REMARKS

Drawing Amendments

FIG. 5

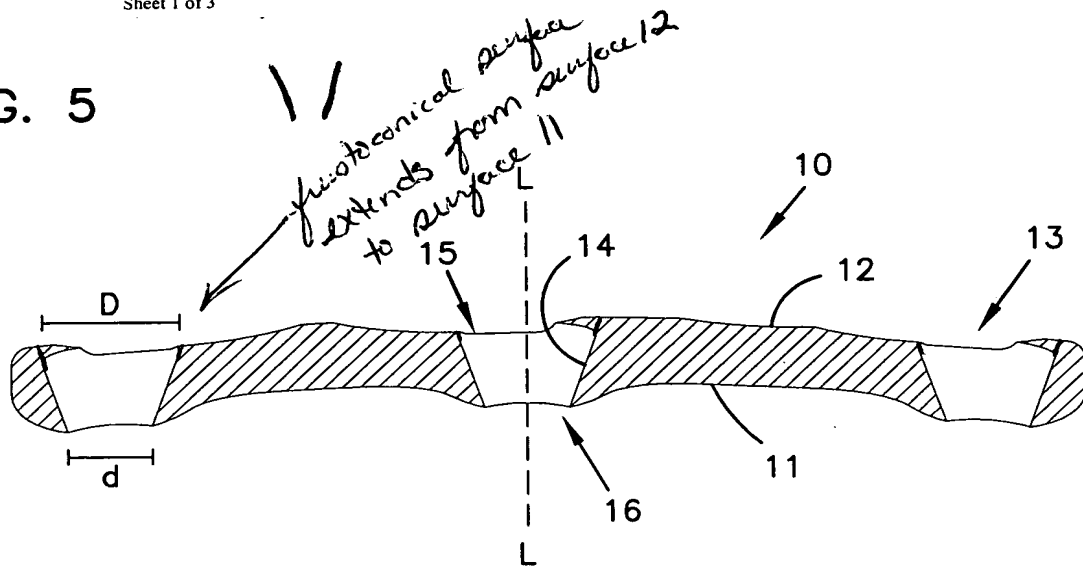
Figures 5-7, 18, 19, and 21 have been amended to correct errors in the formal drawings previously submitted on November 28, 2001. Annotated drawings are enclosed herewith to show the changes made. In particular, Figure 5 has been amended to properly depict the frustoconical inner surfaces of the device. The amendments to Figure 5 are supported in the specification on page 5, lines 22-26. Figure 6 has also been amended to properly depict the frustoconical inner surfaces of the device, the amendments being supported in the specification on pages 5-6, lines 26-8. Figure 7 has also been amended to properly depict the cylindrical inner surface 18 of the device, the amendments being supported in the specification on page 6, lines 8-10.

FIG. 18

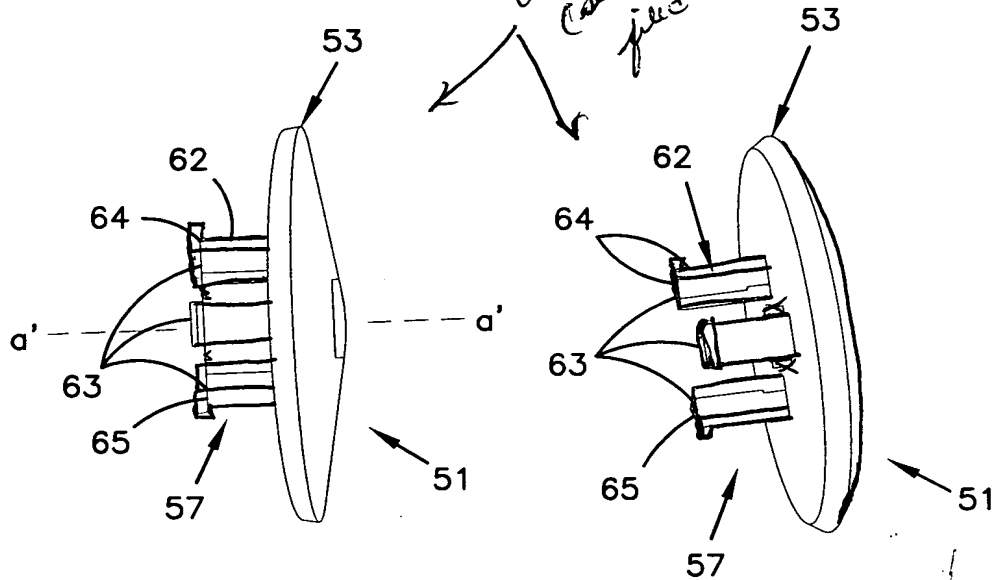
Figure 18 has been amended to properly depict the legs 63 of the locking element 51, as supported by the originally filed Figure 18. Figure 18 has further been amended to add a surface that should be shown in the perspective view. Figure 19 has been amended to clarify that the locking aperture 52 is formed on a surface that is partially shown (i.e. the outer circle should indicate that the surface extends beyond what is shown). Figure 21 has been amended to remove cross-hatching shown in the grooves 61 illustrated in the locking aperture 52.
